Development Permit Notice of Decision

Proposed Development: Retail & Service – General: [REDACTED]
Legal Description: Plan 0421586, Block 05, Lot 03
Municipal Address: 5203-30 Avenue, Beaumont, AB
Land Use District: Commercial
Permit Application No: 2026-091
Tax Roll: 002918

Development Permit Status: Approved with conditions

Development Permit Authorization

1 SITE PLAN
A1-10.1 1:700

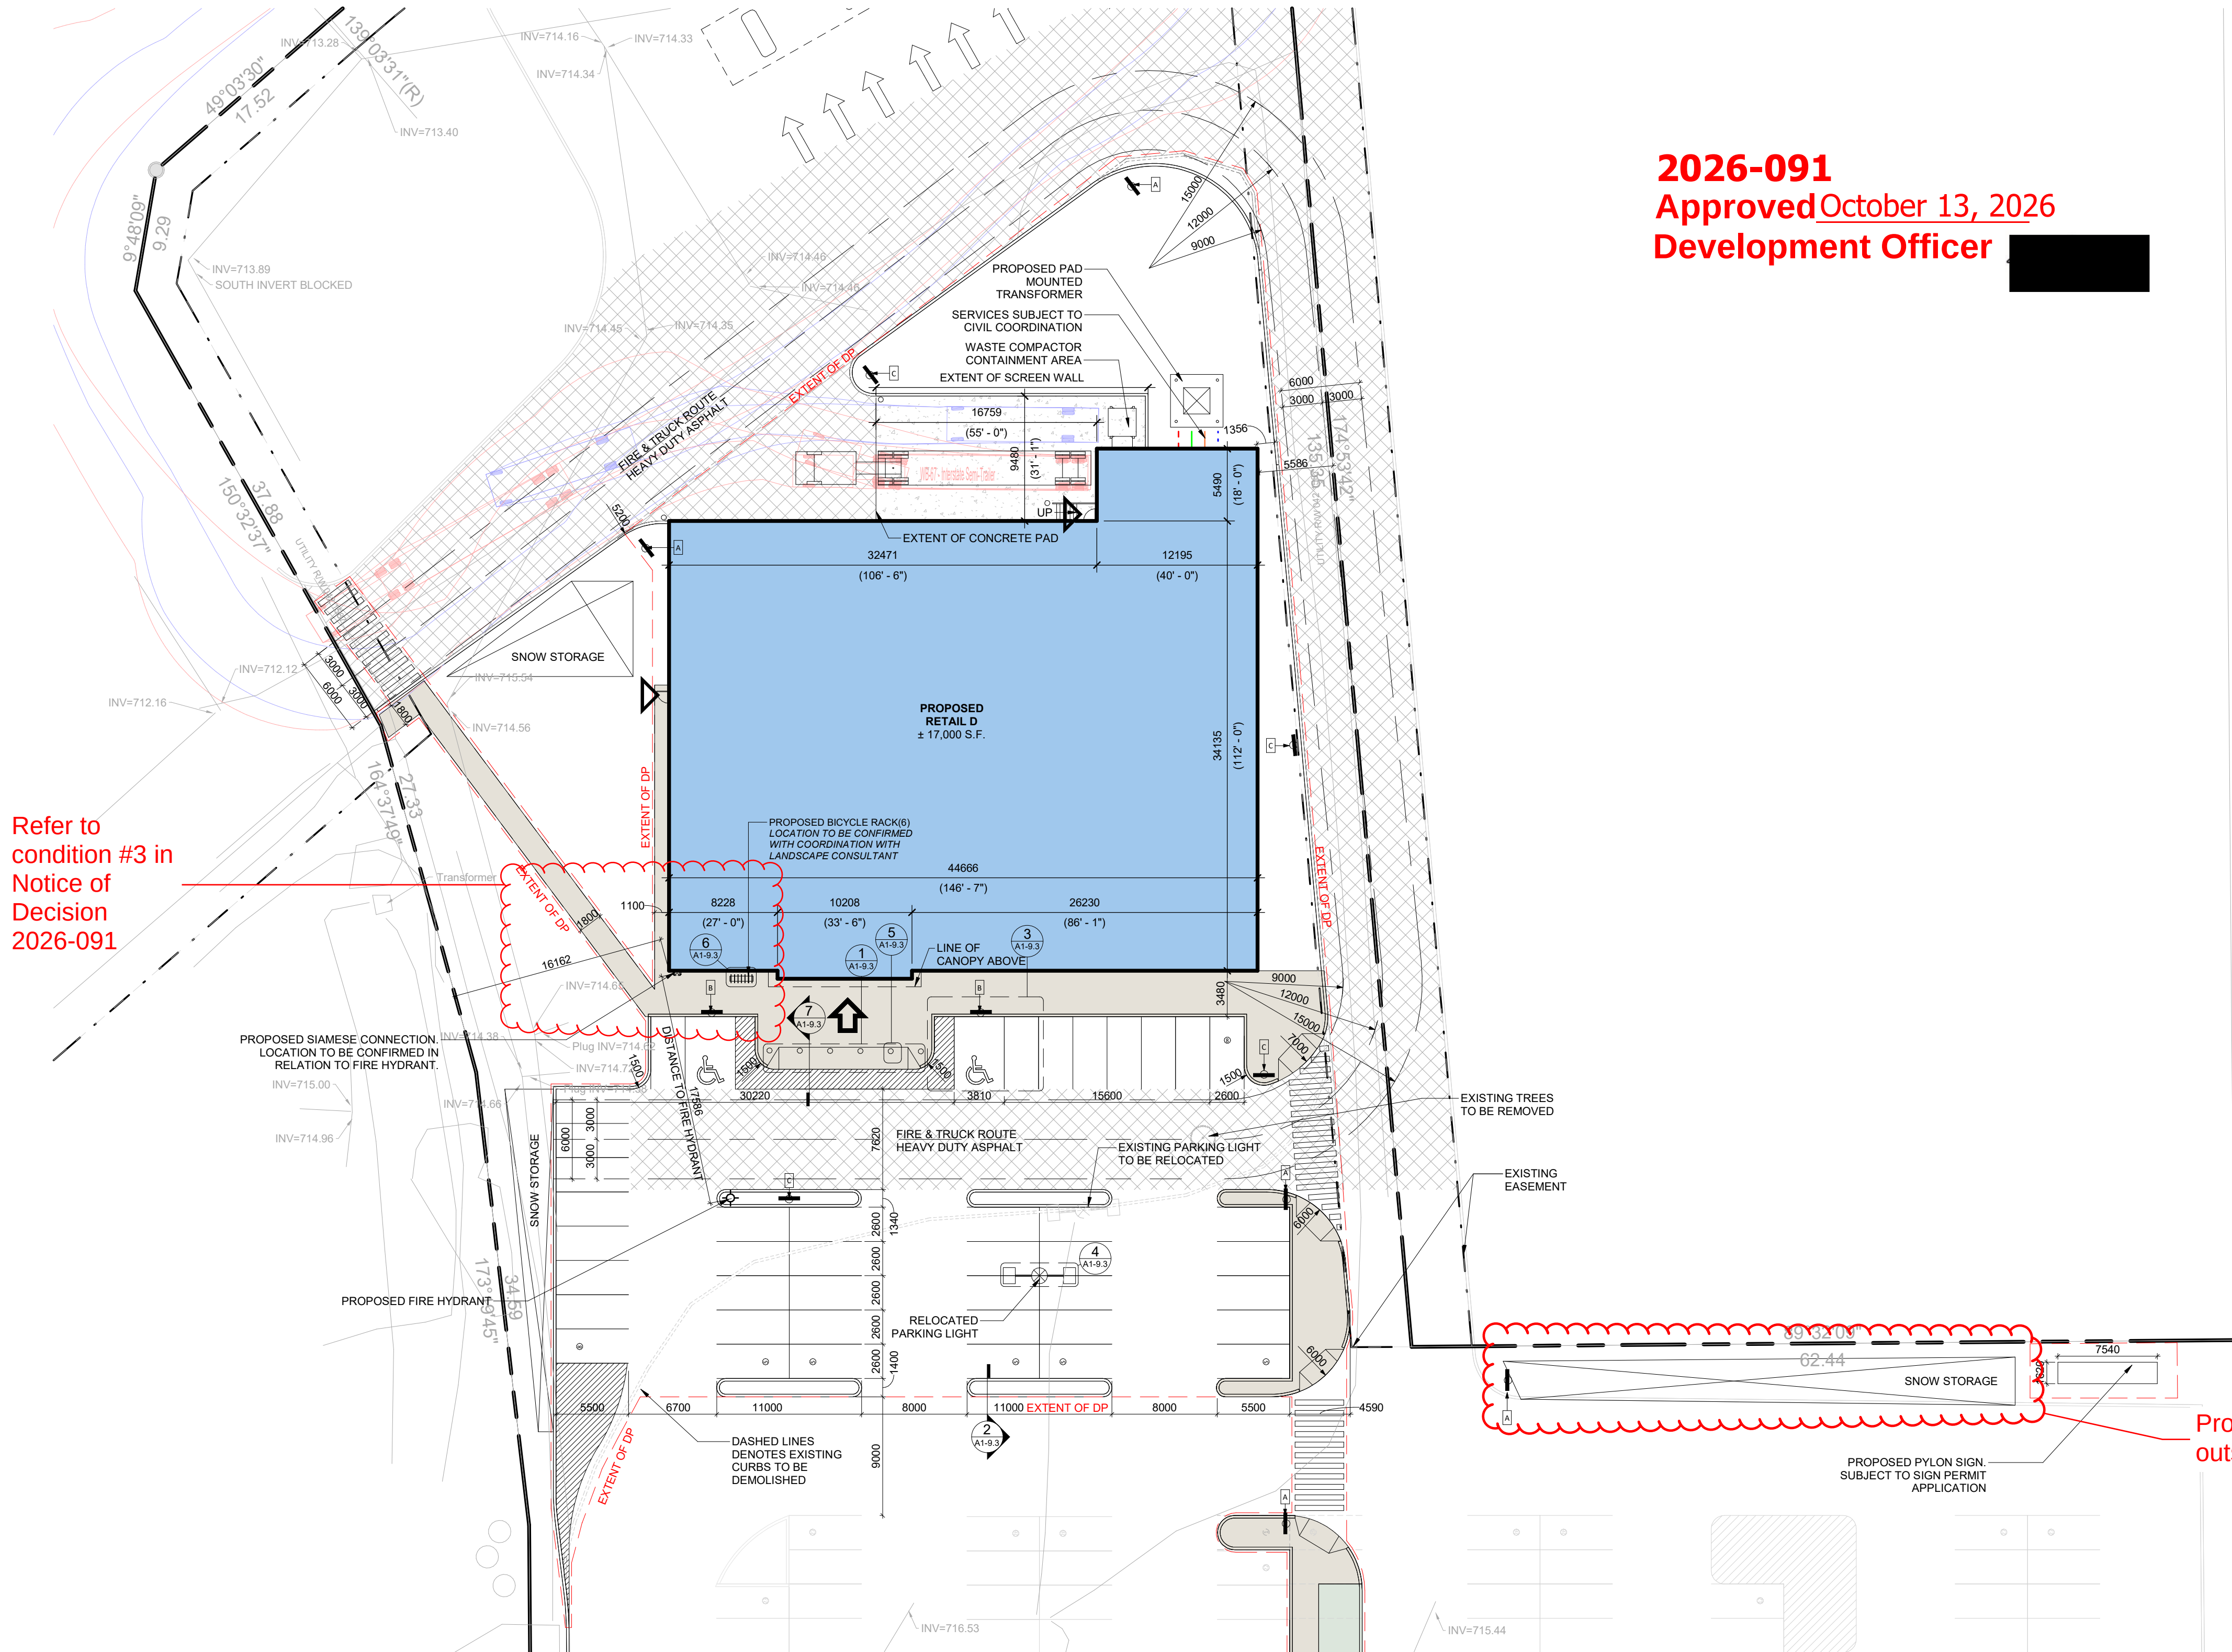
Proposed snow storage conflicts with loading zones of adjacent development. This snow storage area is not included within the development approval. Parking stalls exceed minimum Land Use Bylaw requirements. Over dedicated parking stalls may be used for snow storage.

DRAWING
ENLARGED SITE PLAN

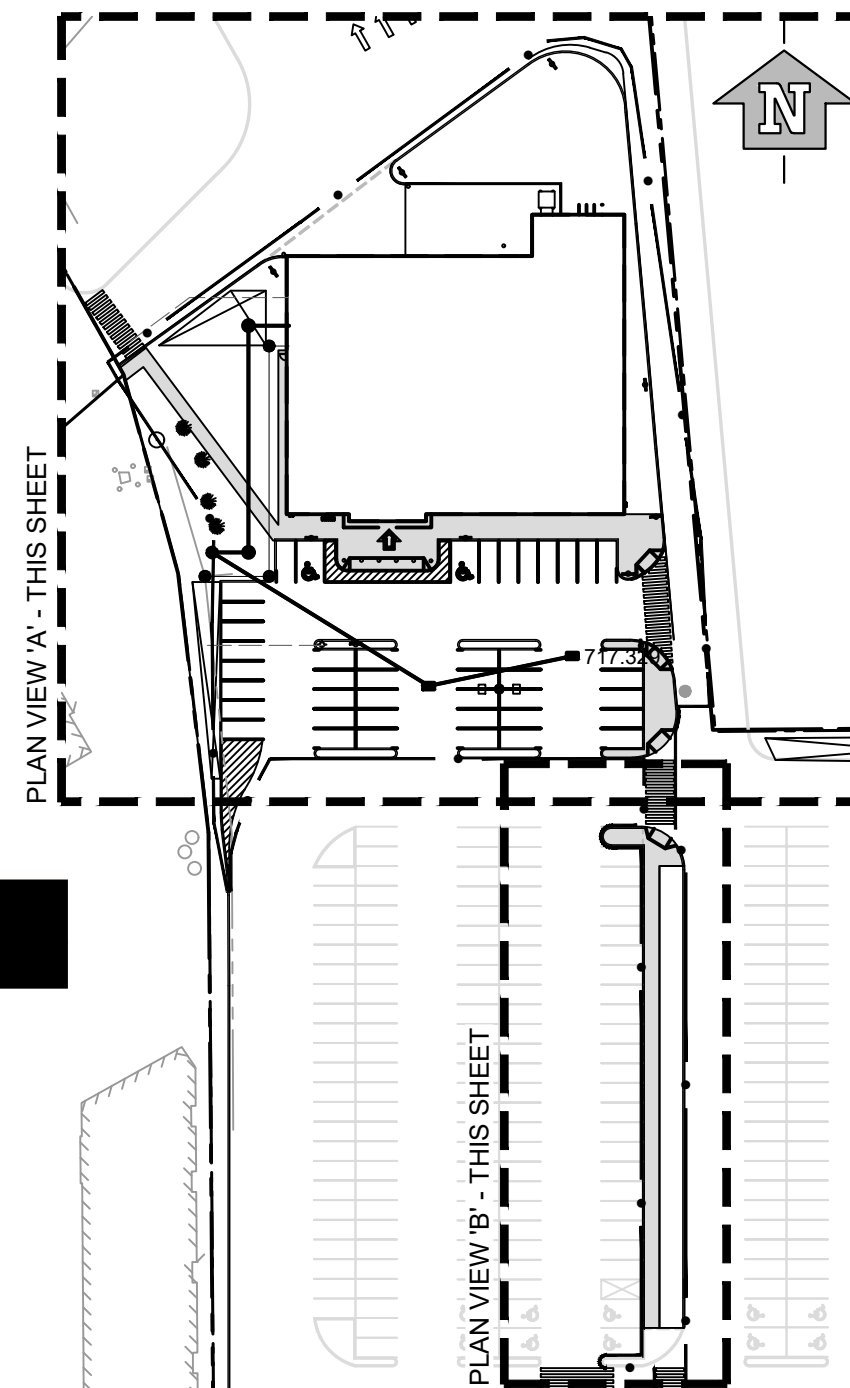
Refer to condition #3 in Notice of Decision 2026-091

3. The applicant shall install one (1) permanent, anchored bench on the southwest portion of the development extent, within the area identified in the attached drawings. The location and materials of the bench shall be to the satisfaction of the City and shall be accepted in writing prior to installation. The bench shall not obstruct access to the bicycle racks or the siamese fire department connection.

LANDSCAPE STATISTICS, PLAN & DETAILS

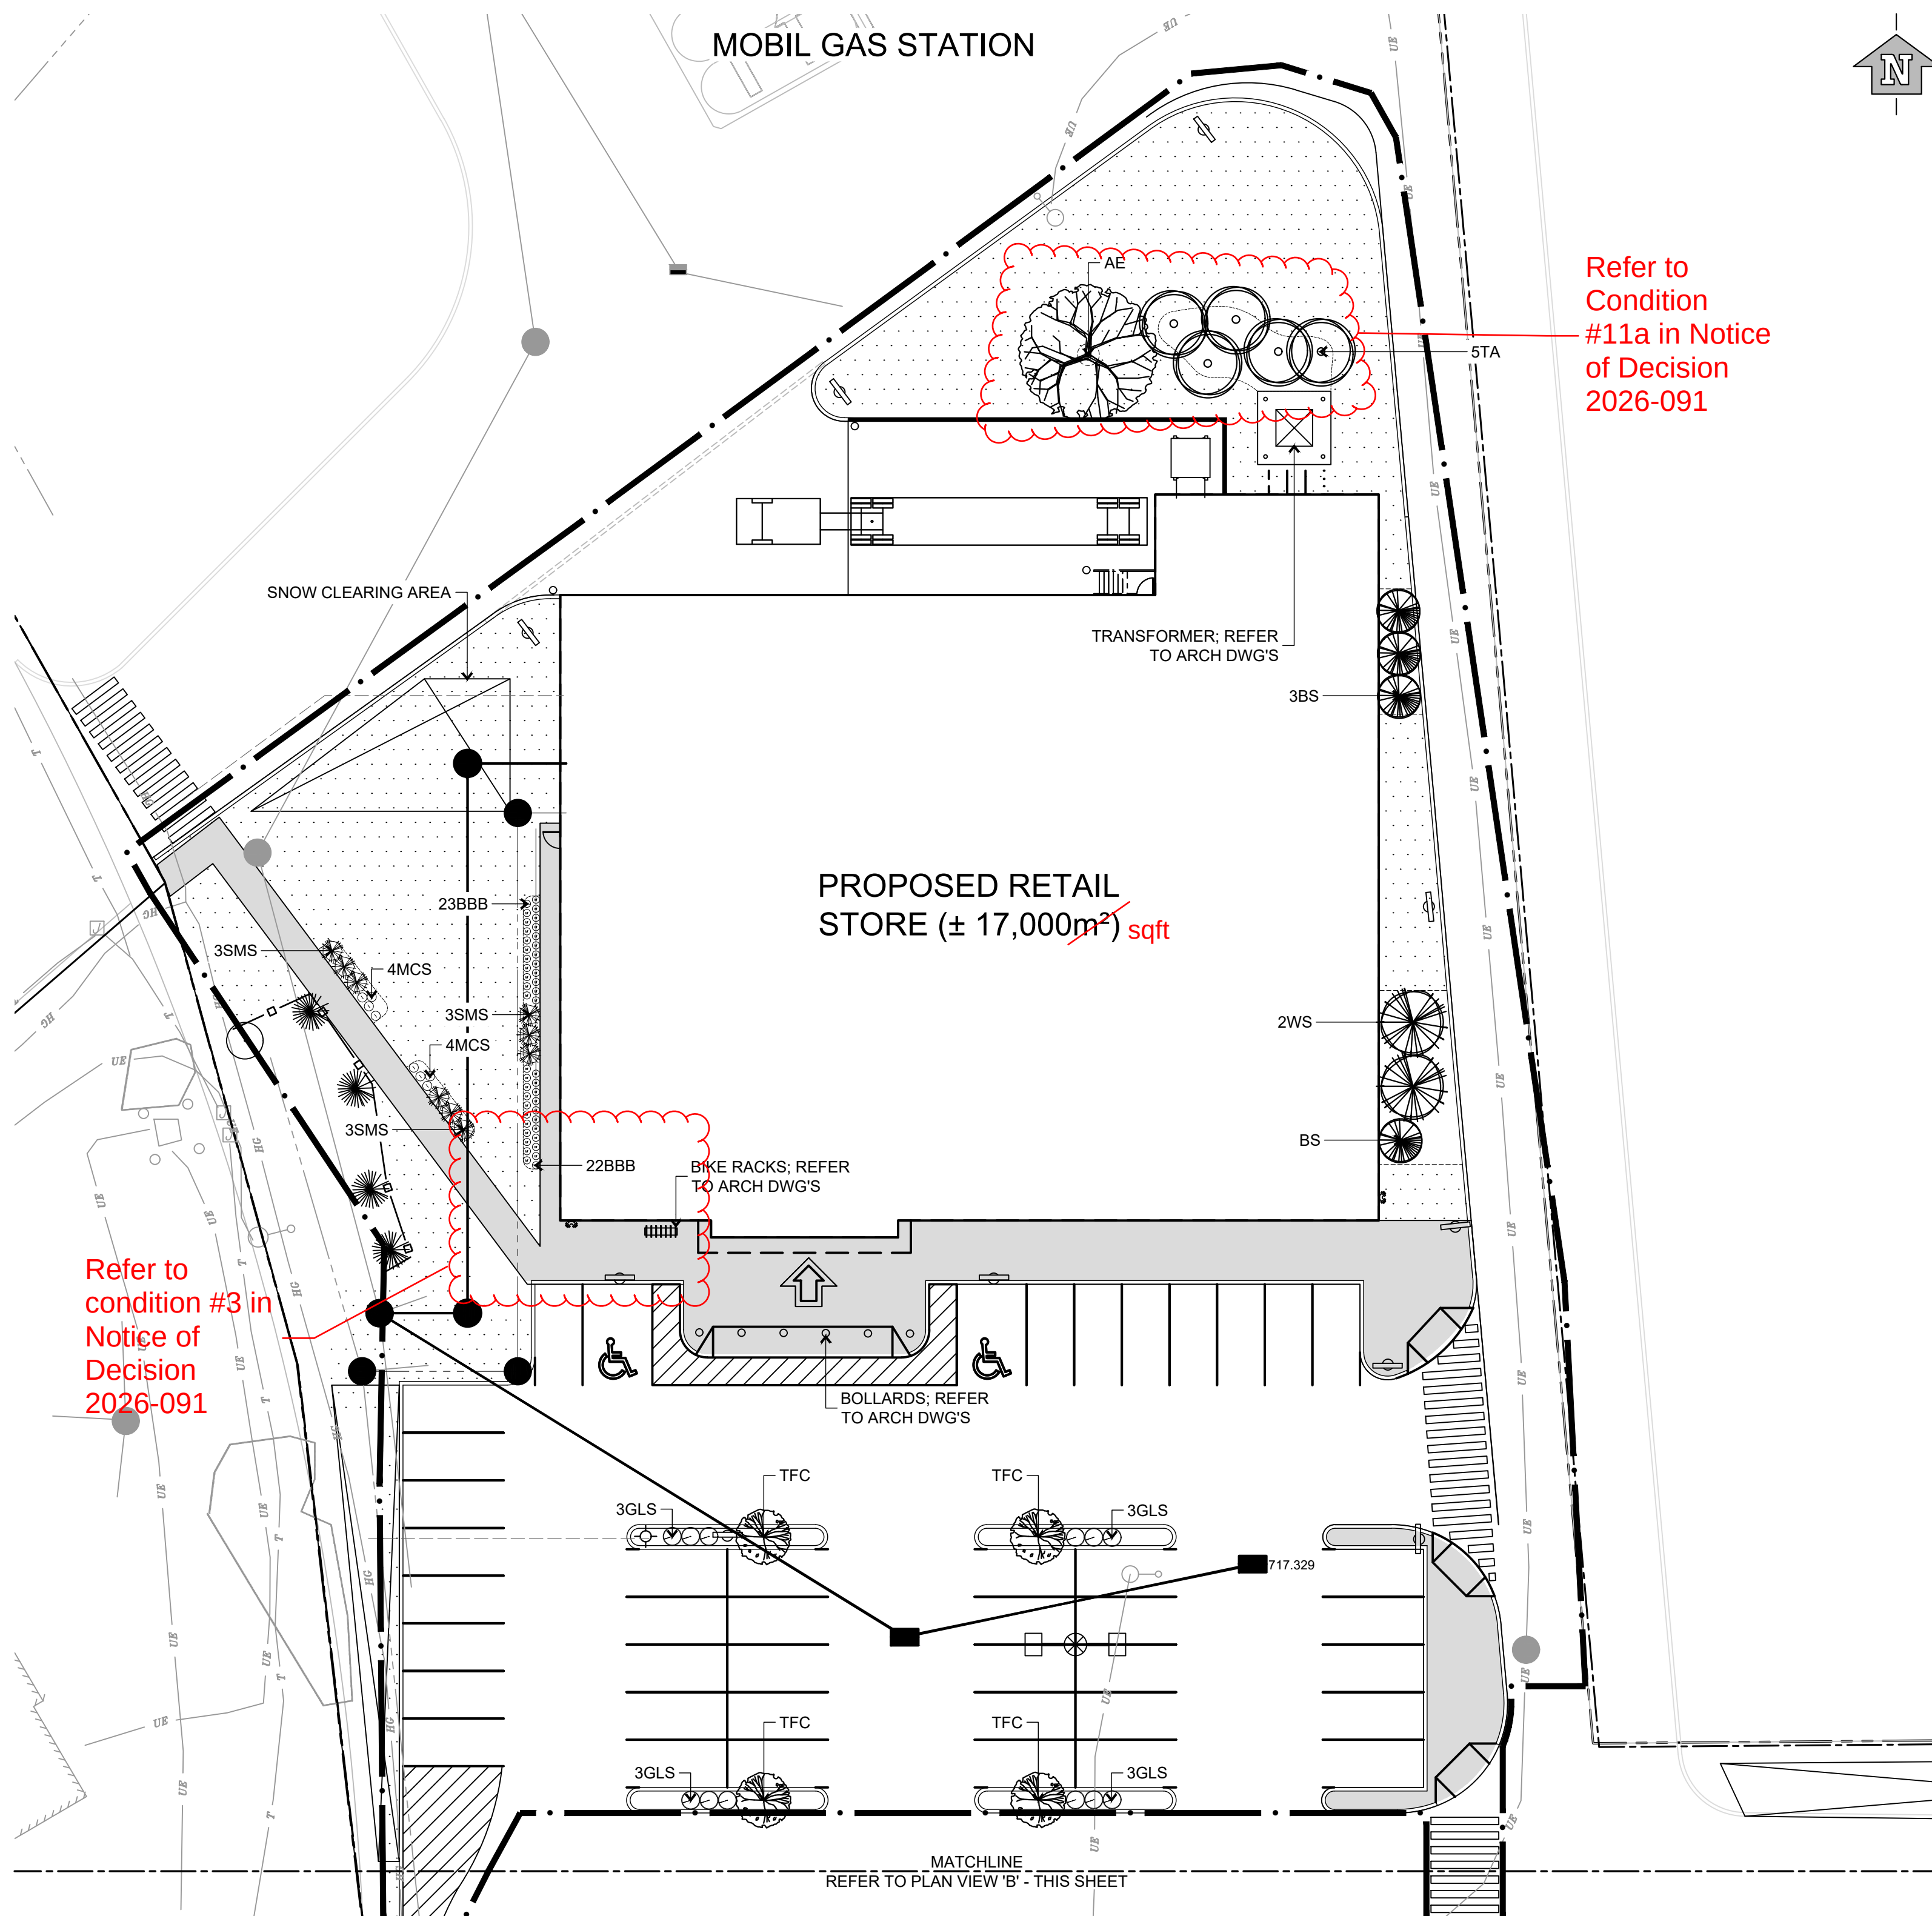
- a. The northeast landscaping (currently 1 American Elm and 5 Trembling Aspen) shall be revised so that a minimum of three (3) of the six (6) trees are coniferous species, to provide year-round visual interest. The planting area shall also include shrubs beneath the trees. Species, quantities, and placement shall be to the satisfaction of the Development Authority. A revised landscaping plan reflecting these changes shall be submitted to and accepted by the Development Authority prior to execution of the Development Agreement.

3 WEST ELEVATION
A301 1: 100

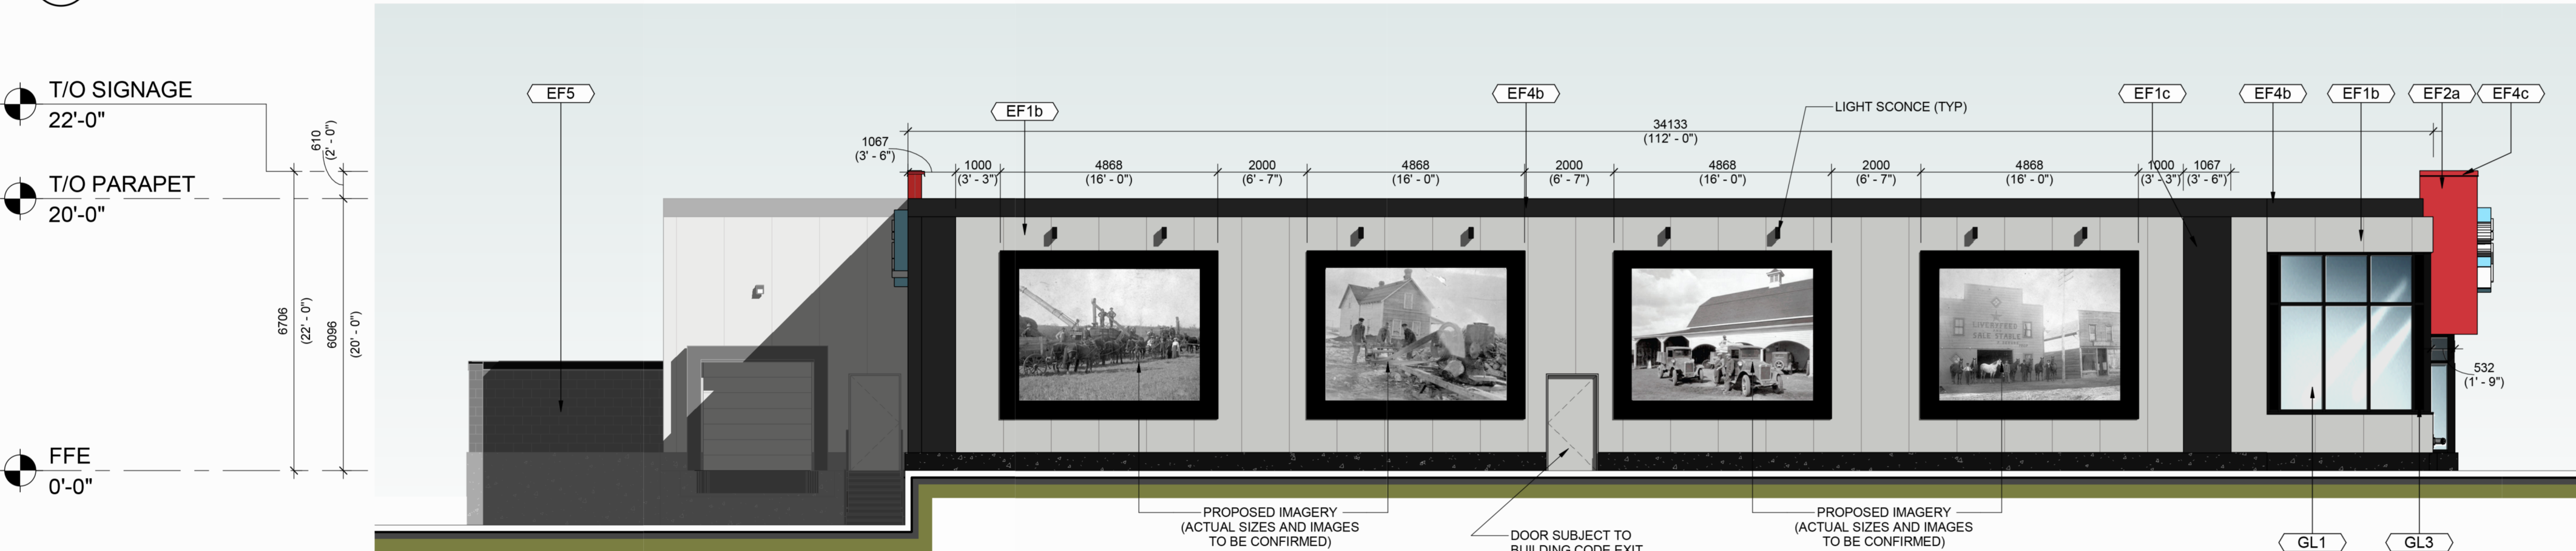
7. Imagery shall be installed and maintained on the west building elevation in accordance with the approved elevation drawings. The imagery shall:
 - a. Be weather-resistant and suitable for long-term outdoor exposure; and

- b. Feature a design that complements the French village design theme of the surrounding commercial developments, as expressed in Principal 1: Distinct Identity "Sense of Place" and Principle 2: French Theme-based Design Guidelines within the Place Chaleureuse Outline Plan.

- c. Prior to installation, the final imagery design, size, and location shall be submitted to and approved in writing by the Development Authority. Variations from the concept shown on the approved elevation drawings may be permitted at the discretion of the Development Authority, provided the intent of this condition is maintained.
